U.S. Nuclear Regulatory Commission Meeting
with Nuclear Energy Institute, Material Reliability Program, and
Operating Pressurized Water Reactor Licensees'

Purpose: To discuss NRC staff's technical assessment for vessel head penetration nozzle cracking associated with NRC Bulletin 2001-01, "Circumferential Cracking of Reactor Pressure Vessel Head Penetration Nozzles."

**NRC-FUNDED
CRDM STRESS ANALYSIS, CRACK-DRIVING
FORCE, AND LEAK-RATE ANALYSES**

**NRC-FUNDED
CRDM CRITICAL CRACK SIZE ANALYSES**

Example of ultra-fine mesh – Emc²

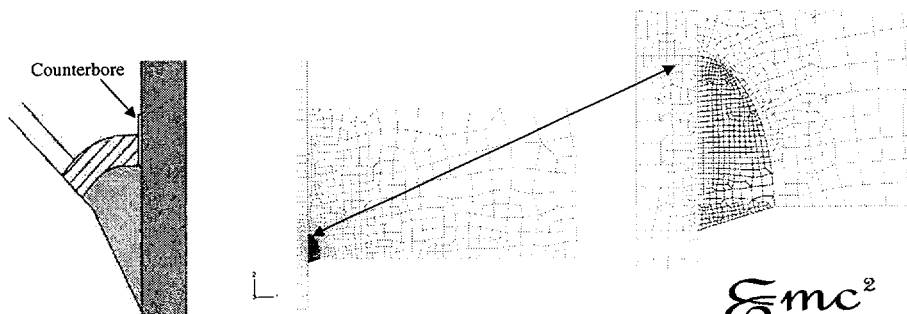
- Some suggested improvements, continued;
 - ❖ Mesh refinement in the weld bead could perhaps be finer
 - Informal survey of international weld stress analysts showed they typically used a minimum of 12 to 20 element in a single weld bead cross-section. (Consistent with Emc² experience.)

Refined Mesh B
8015 elements
31,629 nodes

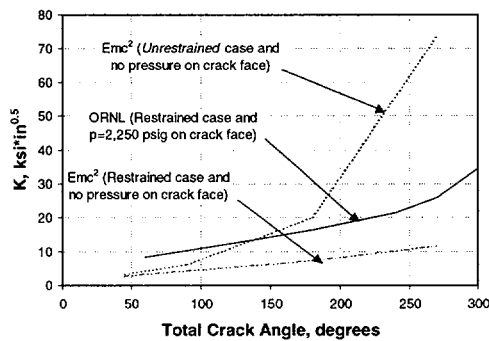
- ORNL effort used gap elements to restrain bending and was elastic-plastic with pressure loading only, including full pressure on crack faces.
- Similarly showed lower COD and K values with restrained bending – particularly for longer cracks.

Figure 15 Estimated stress intensity factor K for a CRDM nozzle based on SIA and ORNL results.

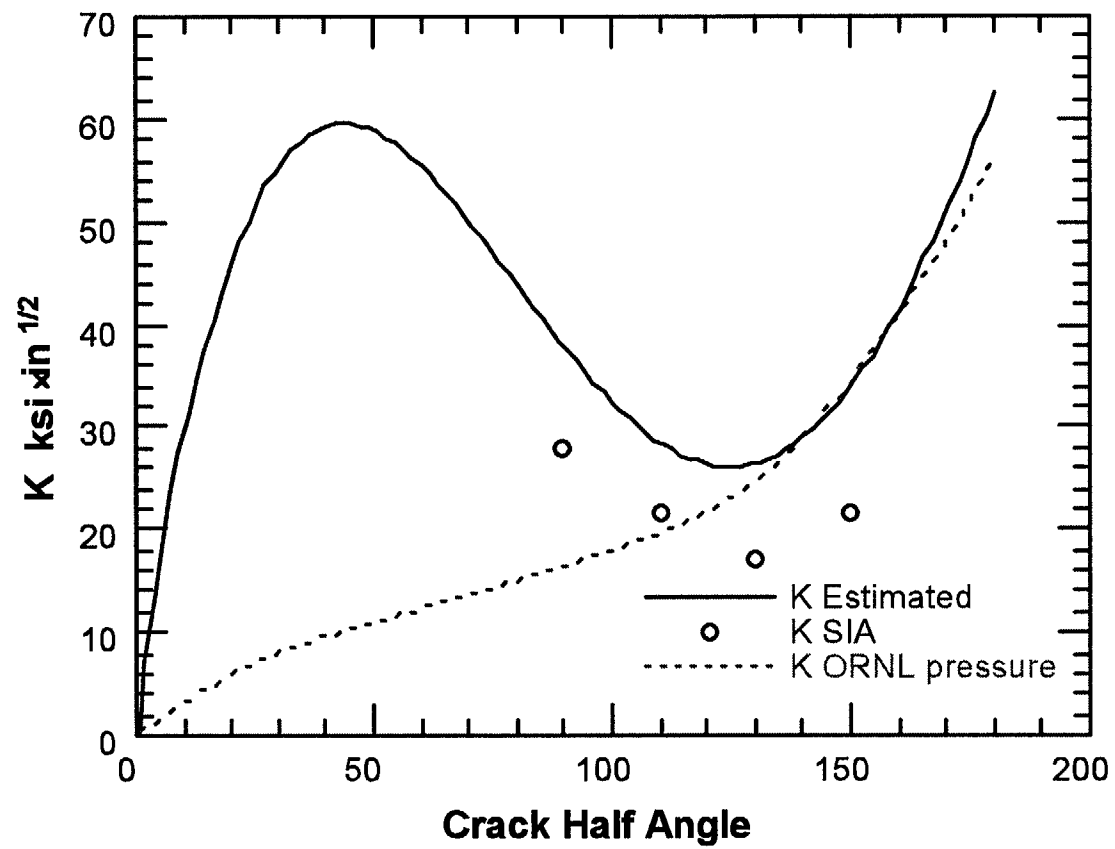
- A single estimate for K as a function of circumferential crack length was provided (with a value of $66 \text{ MPa}\sqrt{\text{m}}$ ($60 \text{ ksi}\sqrt{\text{in.}}$) due to residual stresses for a crack angle of 90°)
